Planning Commission Regular Meeting

Wednesday, December 06, 2023 at 6:30 PM

- [A.](#) Staff Report 23-060, Request for Conditional Use Permit CUP 23-08 for a Planned Unit Development at 1563 Homer Spit Road, 1663 Homer Spit Road, and 1491 Bay Avenue.

LIGHTHOUSE VILLAGE DEVELOPMENT
 DOYON, LIMITED
 1563 & 1663 HOMER SPIT ROAD, HOMER, AK
 COVER SHEET

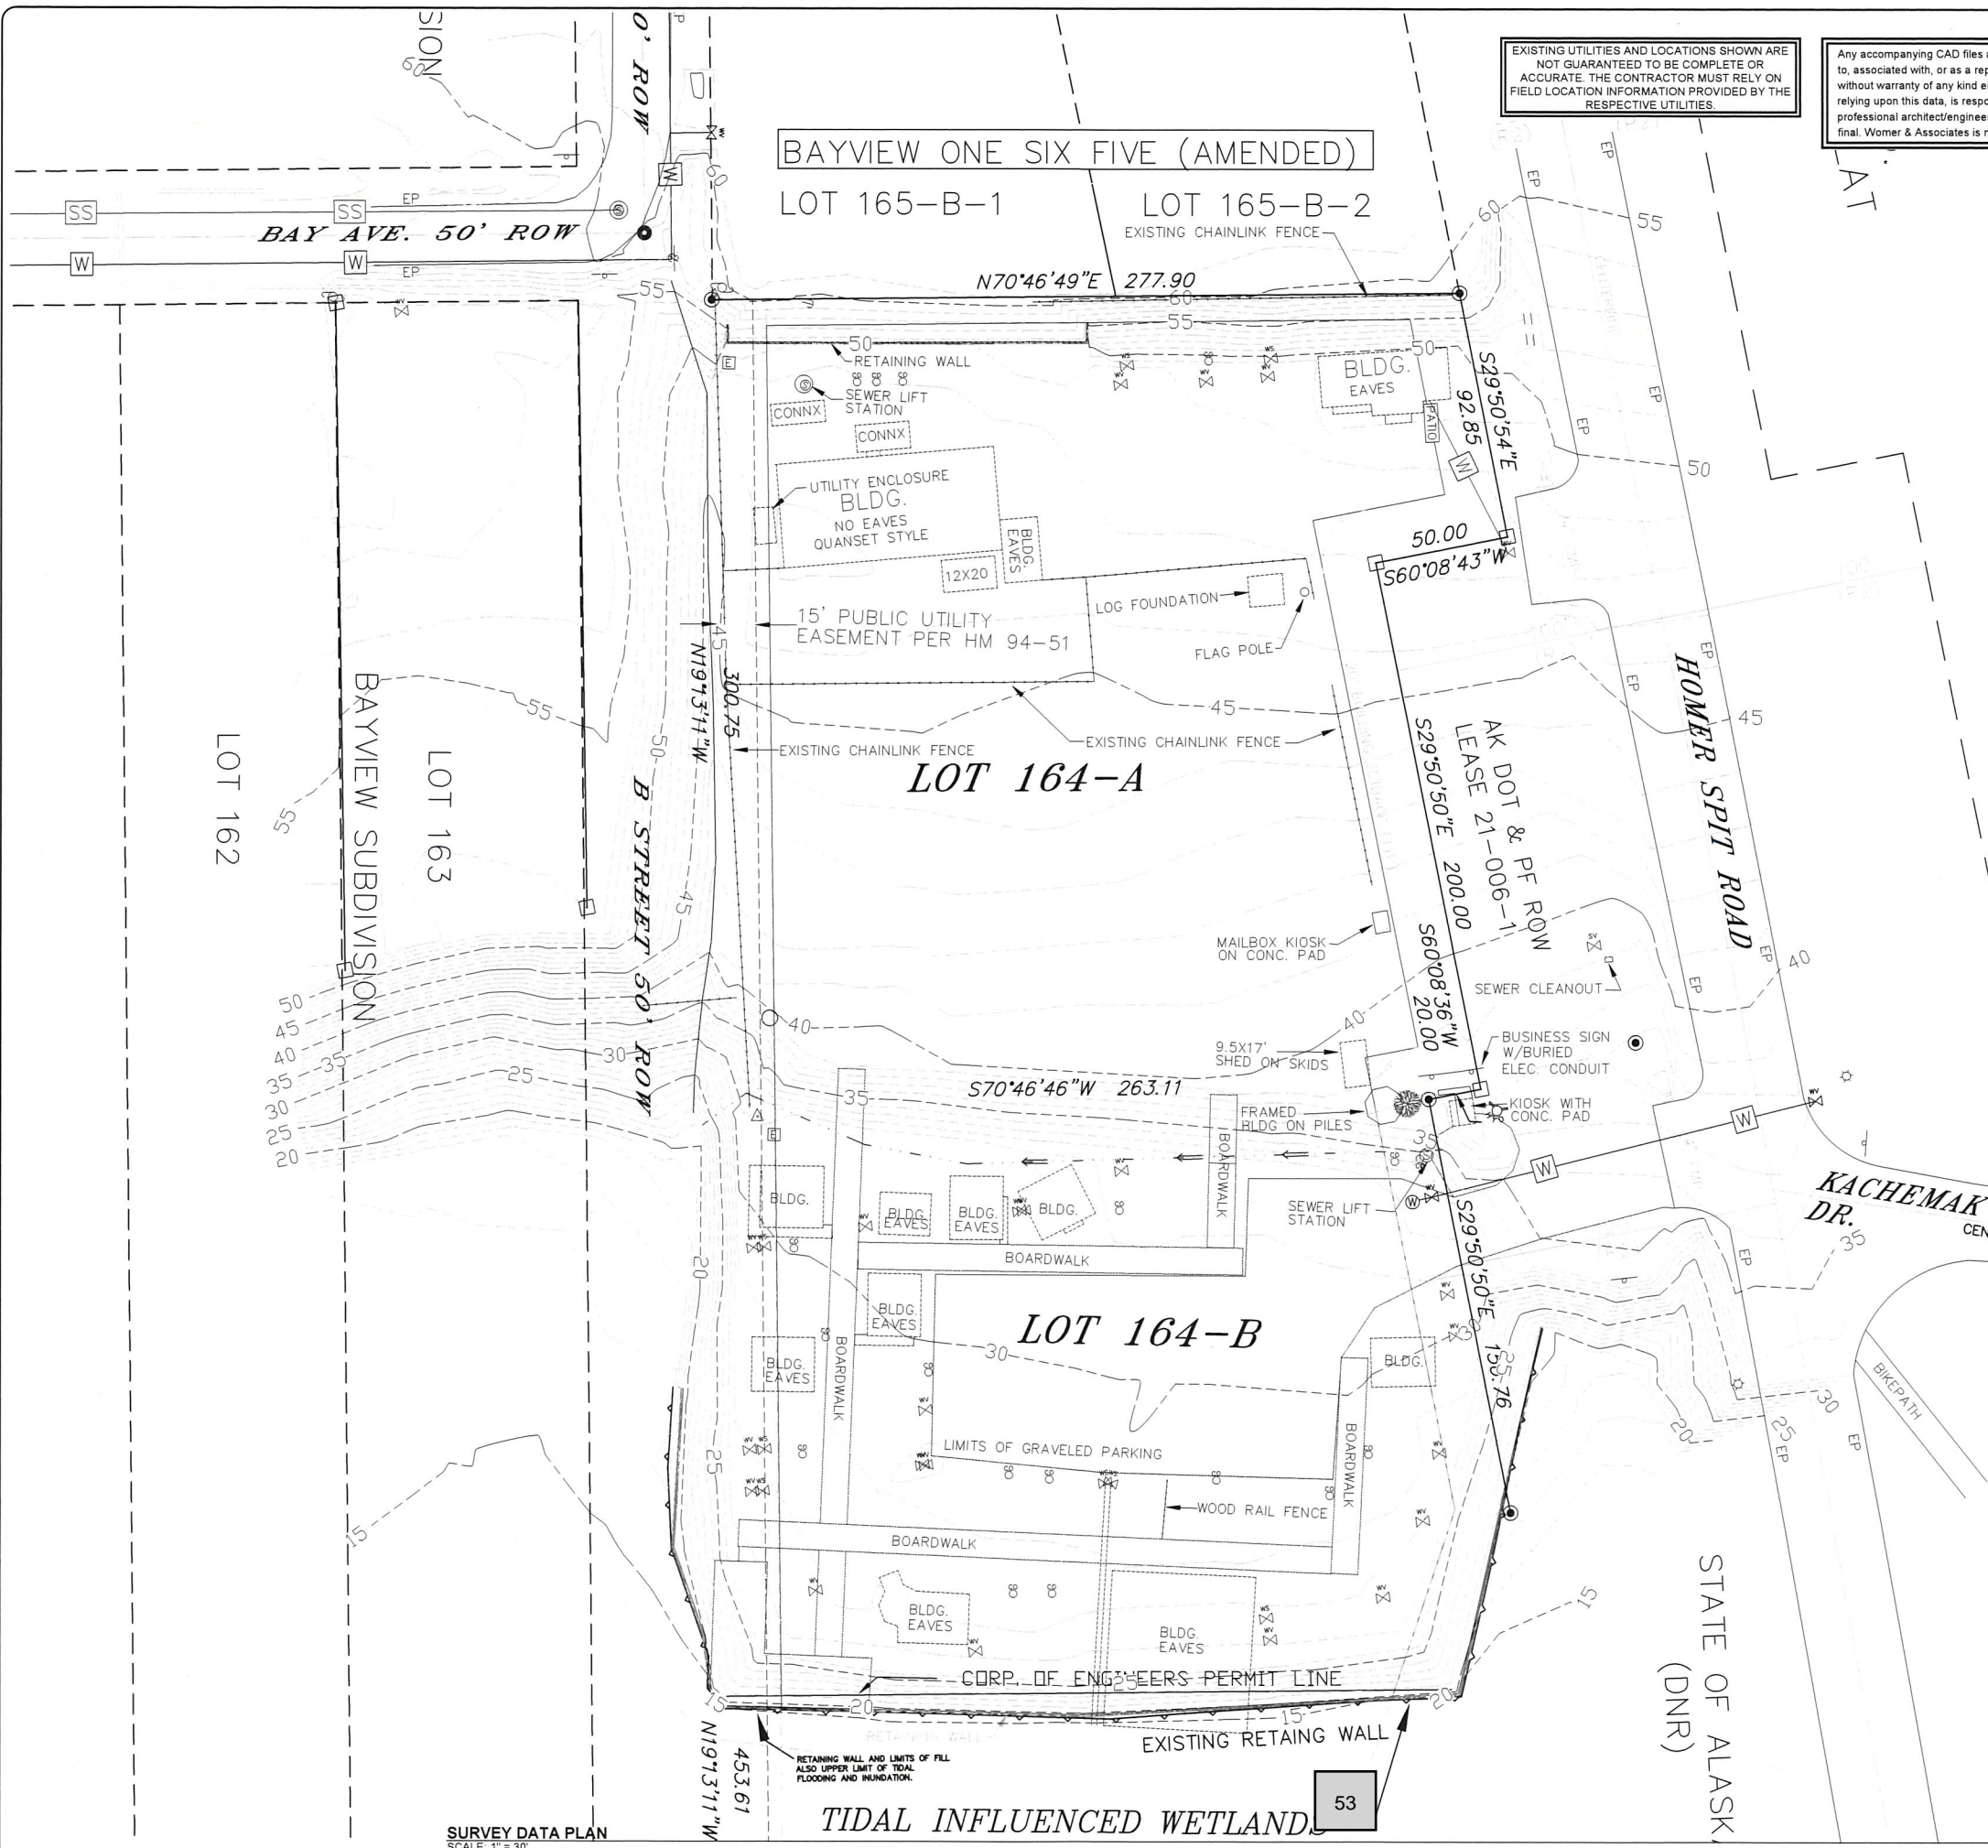
- f. Sheet C4.00 does not show traffic signs or other permanent traffic control devices.
 - Recommendation: Provide a permanent traffic control plan
- g. Sheet G0.00 refers the "infamous Homer Spit".

- Recommendation: delete the word "infamous" as it has no pertinent context here and serves no useful purpose.
- h. Sheet G0.00 refers to "adopted codes", which the City of Homer does not have.

- Recommendation: Architect should identify with specificity which codes apply.
- i. Sheet G0.00 does not address adjacent wetlands or a buffer between developed areas and preserved areas.

LIGHTHOUSE VILLAGE DEVELOPMENT
 DOYON, LIMITED
 1563 & 1663 HOMER SPIT ROAD, HOMER, AK
 SURVEY DATA PLAN

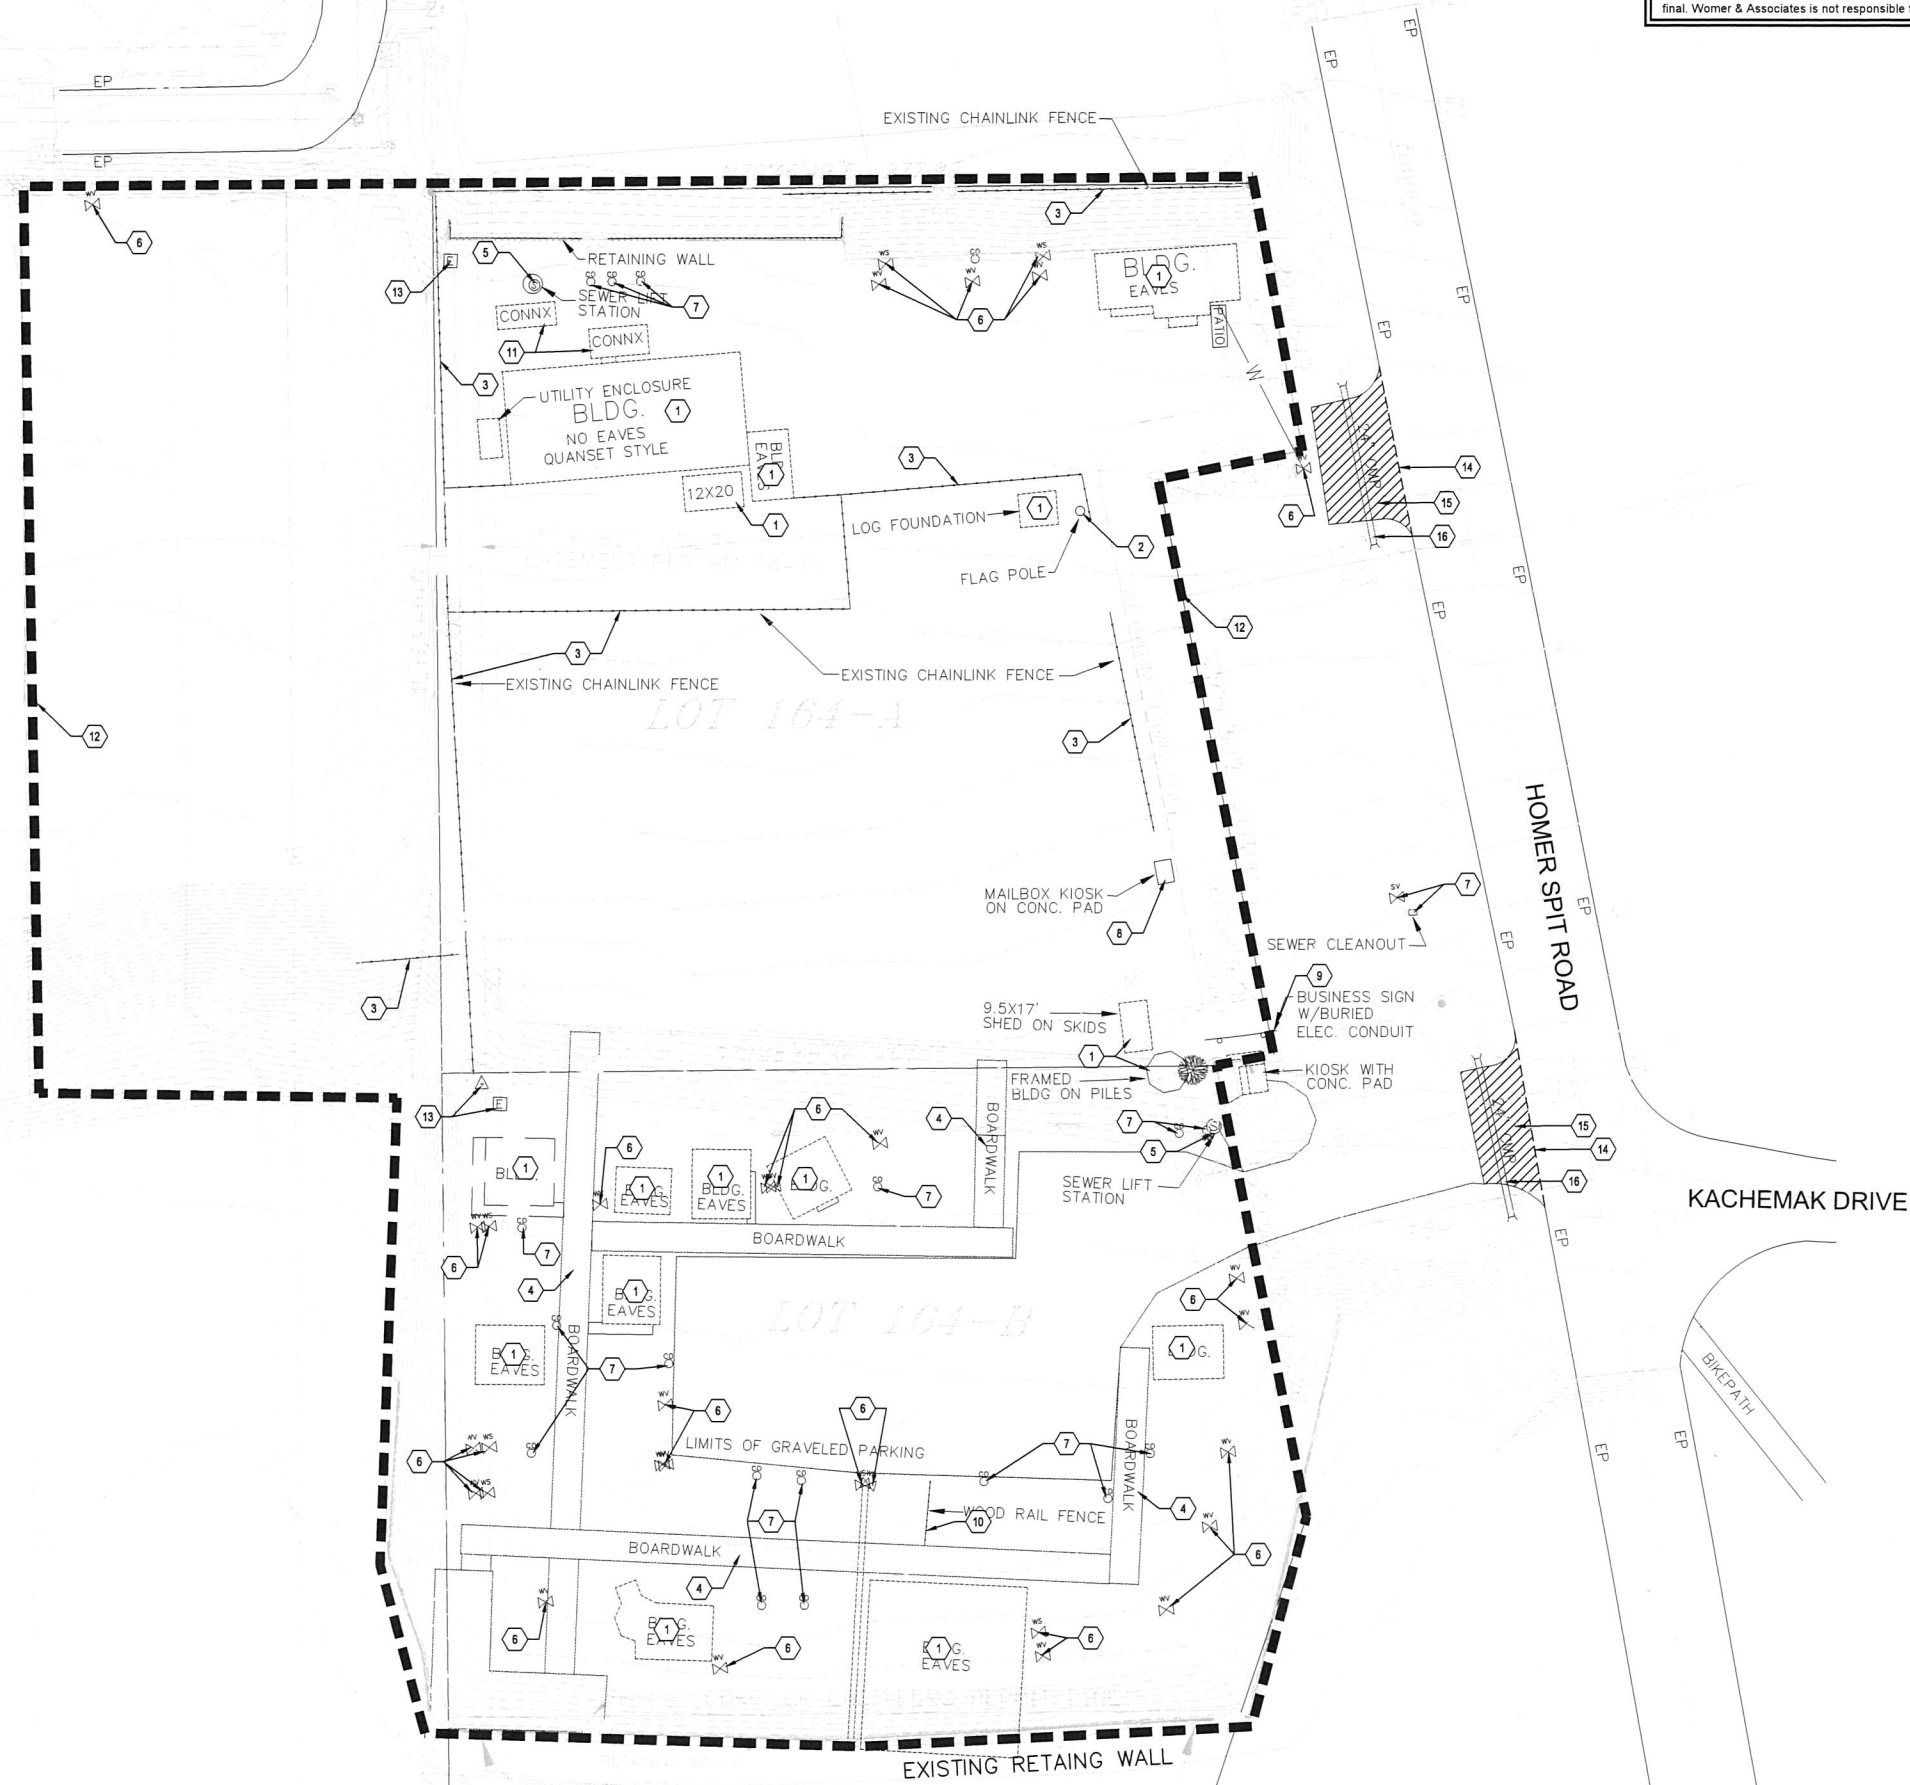
- a. Sheet C1.00 shows the eastern boundary of the 15' public utility easement, but not the western boundary.
 - Recommendations:
 1. Show the western boundary of this easement.

2. Include a copy of the public utility easement with the CUP package.
- b. Sheet C1.00 does not show the existing wooden viewing platform that provides access for public viewing of wildlife in the adjacent wetland.

- Recommendation:
 1. Show this existing structure on the plan sheets.
- c. Sheet C1.10 does not show that the existing wooden viewing platform exists or will be demolished/replaced.

GRADING PLAN
 SCALE: 1" = 30'

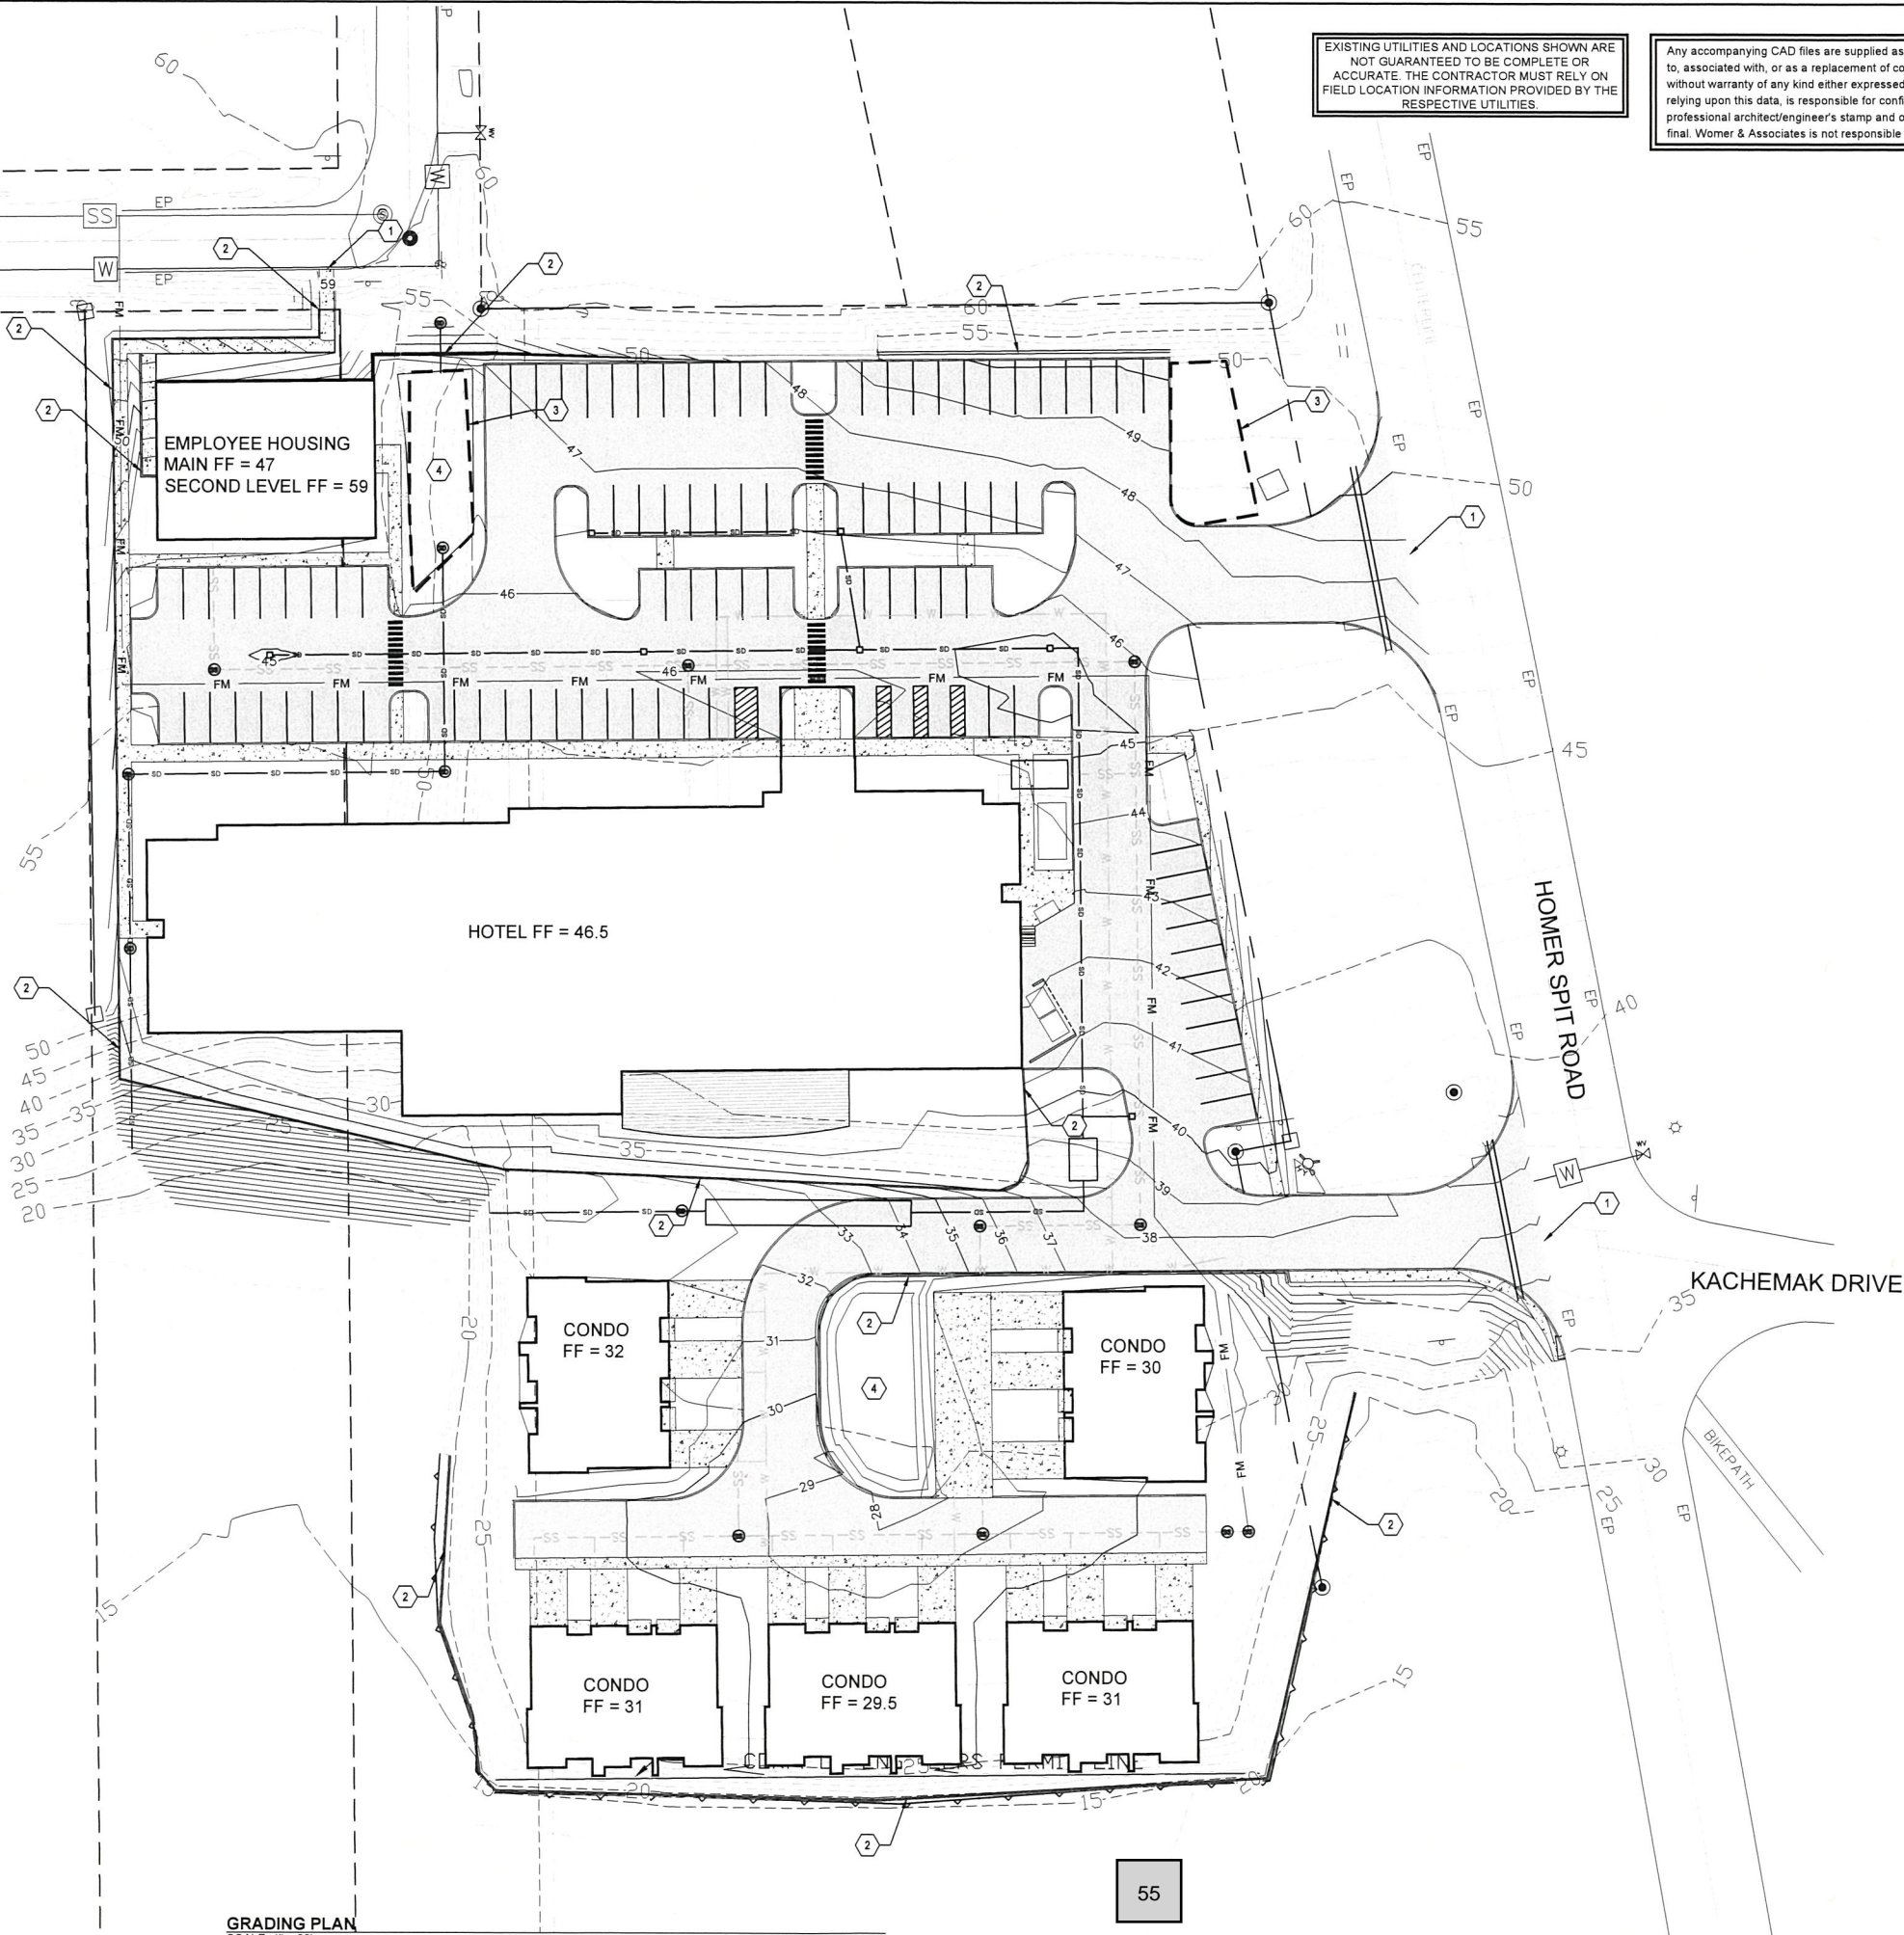
- Recommendations:
 1. Show the existing wooden viewing platform and indicate that it will be demolished.
- d. Sheets C2.00, U2.00 and AS0.01 do not show details of the culverts, swales, rain gardens or other green infrastructure features.
